2751 n 50th street- Addendum 002

Tuesday, July 03, 2012

Change to scope of work included in bid and clarification: All bidders shall incorporate the following into their scope of work and bid price.

2751 N 50TH STREET
1ST FLOOR PLAN - EXISTING

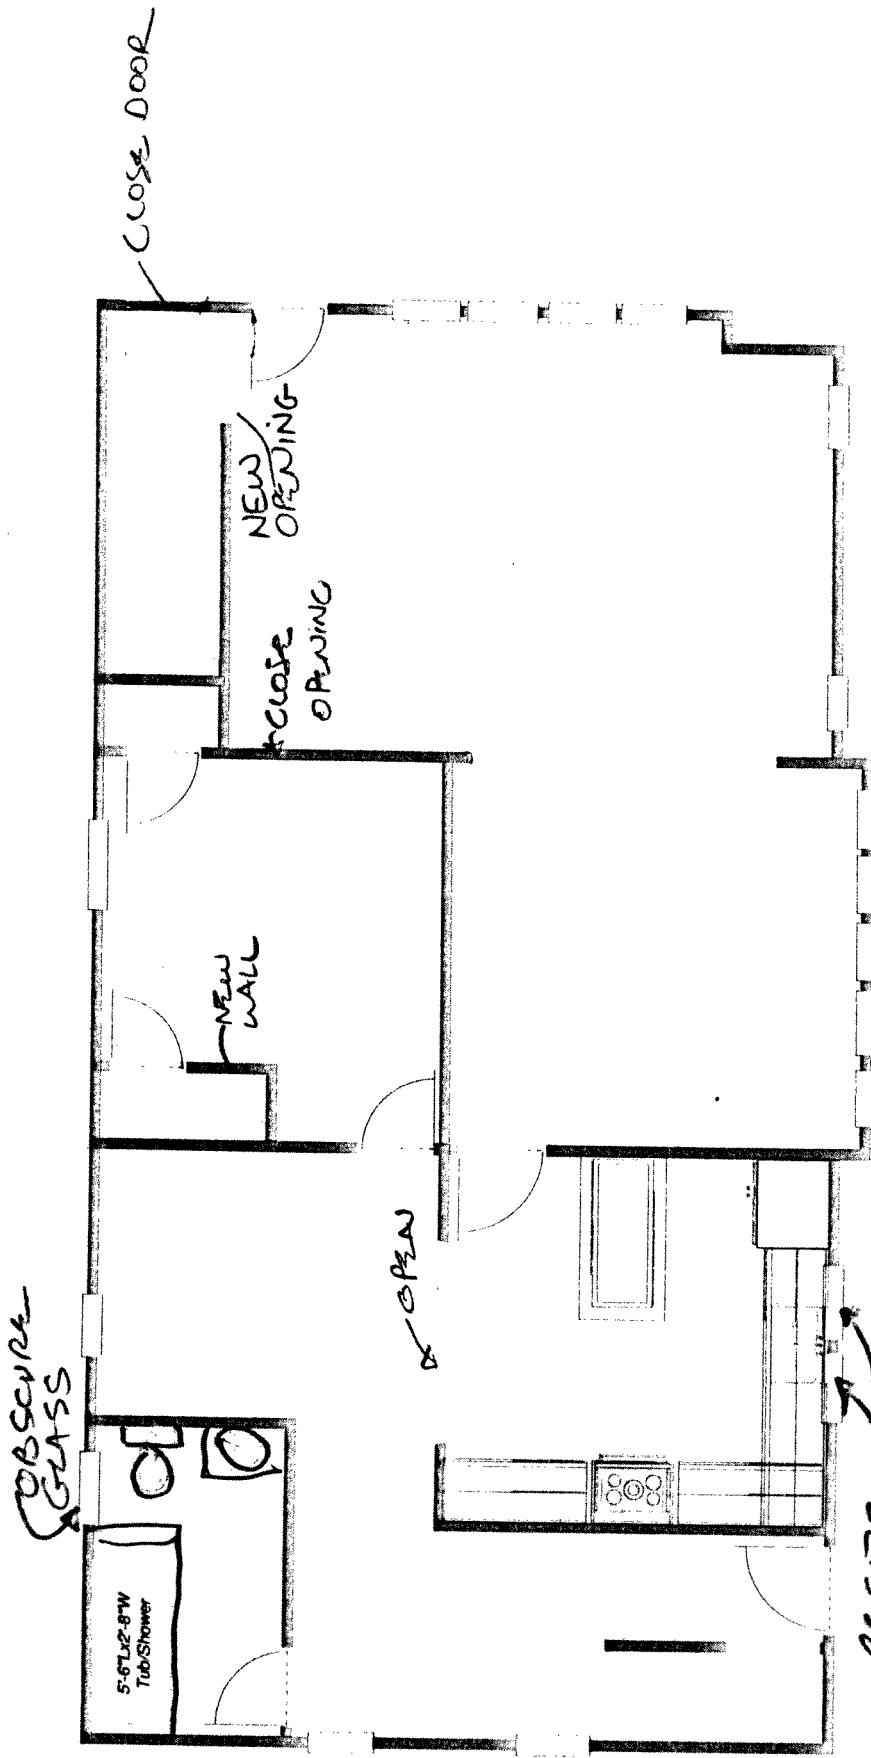
| spec code | Description of work | Note: | Item code | Bid category | Itemized cost |
|----------------------|---|-------|--------------|-------------------------|---------------|
| 6100 9250 | reconstruct cove ceiling at lower entryway where hallway is removed and new opening to upper floor is being made. | REQ | PbN | General Bid | |
| 2050 6100 9250 | The existing west bath wall is to be left in both units remove finishes both sides to allow plumbing pipe installation. | REQ | PbN | General Bid | |

NORTHWEST CORNER
WINDOW REFRAME

2751 N 50TH STREET
2ND FLOOR PLAN EXISTING

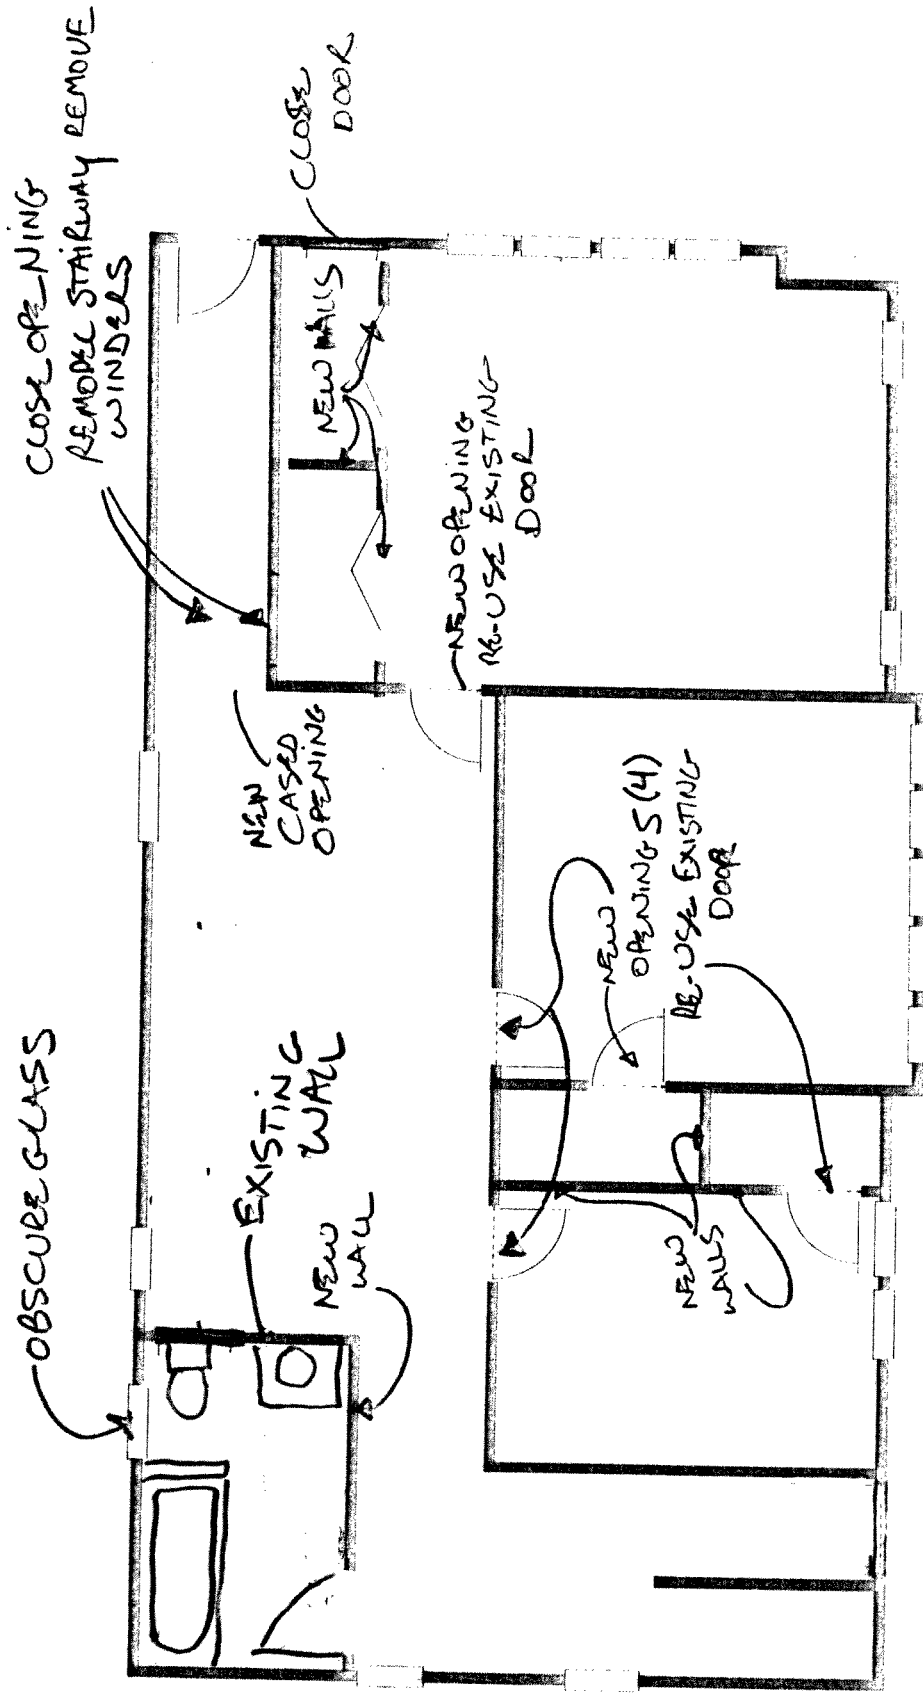
NORTHWEST CORNER
WINDOW RE-FRAME

WINDOW SIZE TO REMAIN
